***Housing Element & Safety Element
Updates***

Final Environmental Impact Report

City of Benicia

***HOUSING ELEMENT &
SAFETY ELEMENT UPDATES
FINAL ENVIRONMENTAL
IMPACT REPORT***

Figure 1: Site Map

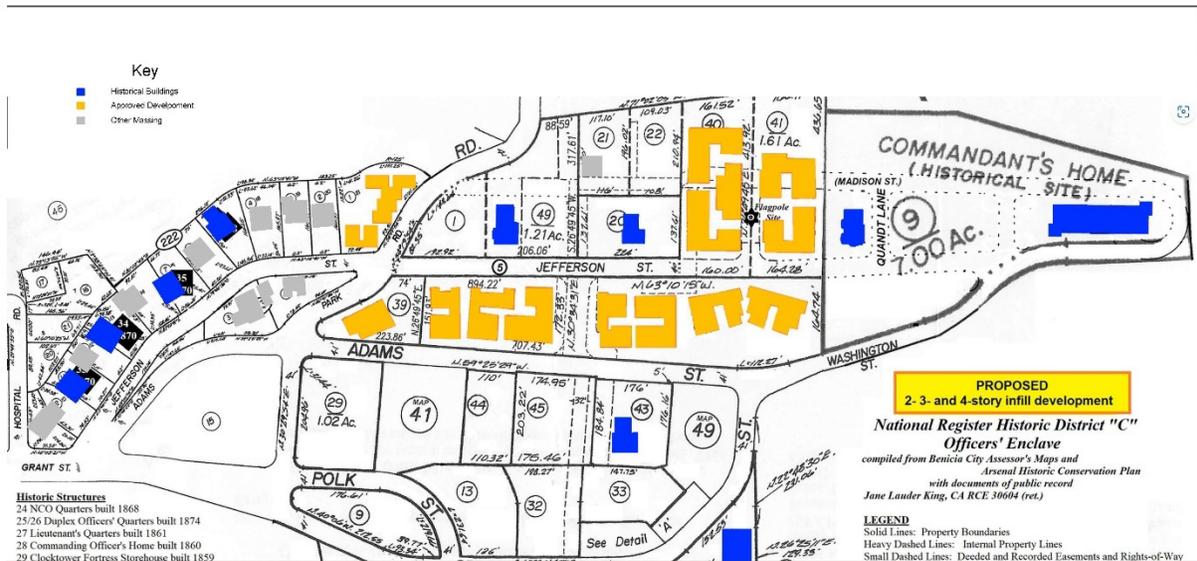
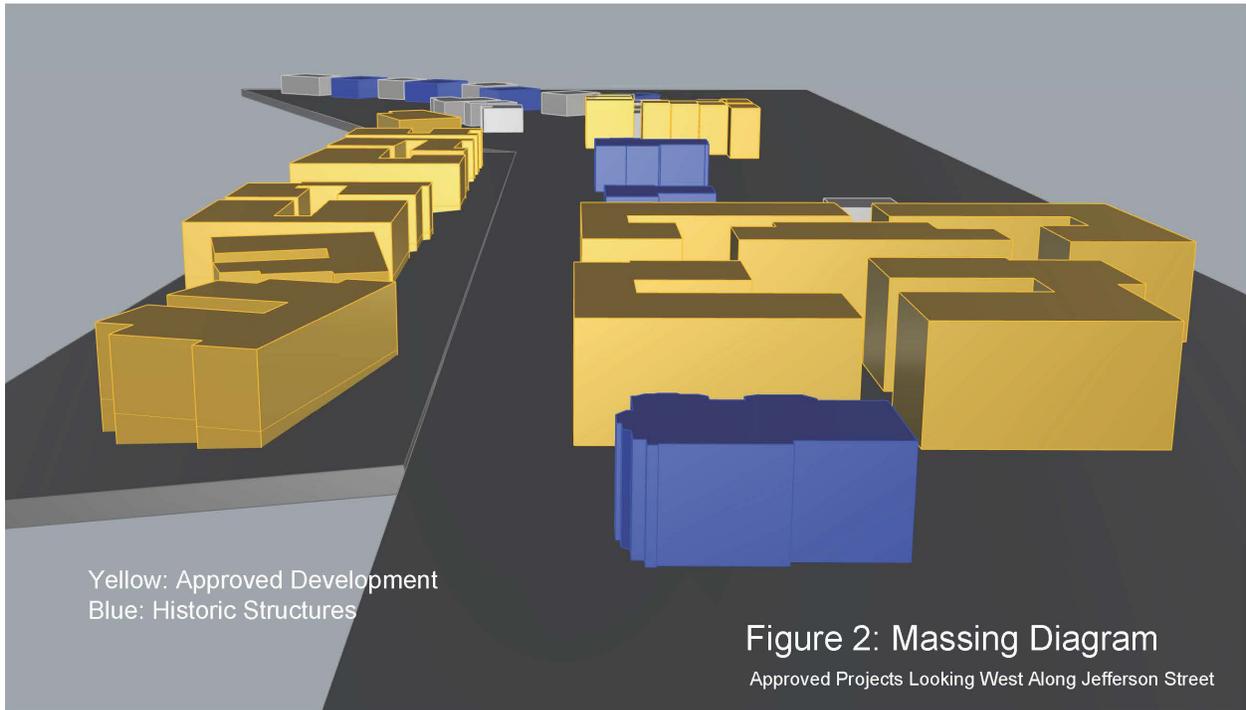
<p>Figure 1 and Figure 2 (attached) were provided at my request to illustrate the impact that development on Jefferson Ridge could have on the Arsenal historic district. Figure 1 presents an overview of the approved developments (approved development in yellow, historic structures in blue) in the Historic District C, showing how the developments isolate the historic structures from each other and eliminate the visual unity that is one of the principal features of the historic district. Figure 2 is a massing diagram viewed from a point above the Commanding Officer’s Quarters looking west along Jefferson Street. It illustrates how the scale of the approved developments would overwhelm the district.</p>	<p>16-8</p>
<p>Implementation of any project on the Jefferson Ridge sites (current approved projects or future unrelated projects) would have profound impacts on the viability of the National Register Historic District and would likely lead to the delisting of this valuable national historic asset. This is a potential impact that should be evaluated and acknowledged in the Housing Element EIR.</p>	<p>16-9</p>

Figure 3-1d
Housing Element Sites Inventory #4

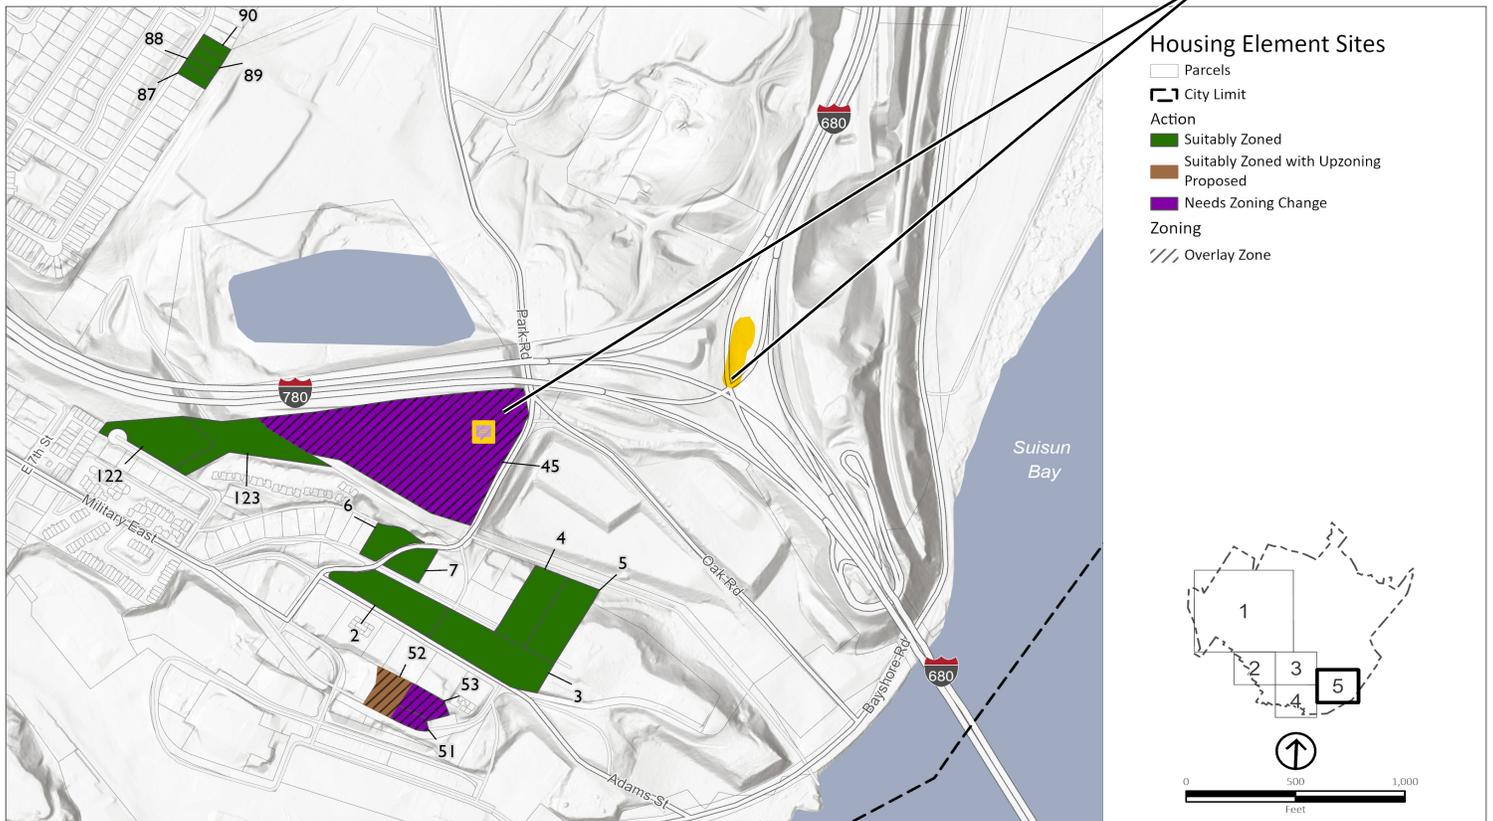
What is the density on this site given the footprint into the bay.

18-5 The commenter refers to Figure 3-1d of the DEIR and asks what the density on the site is given the footprint of the bay.
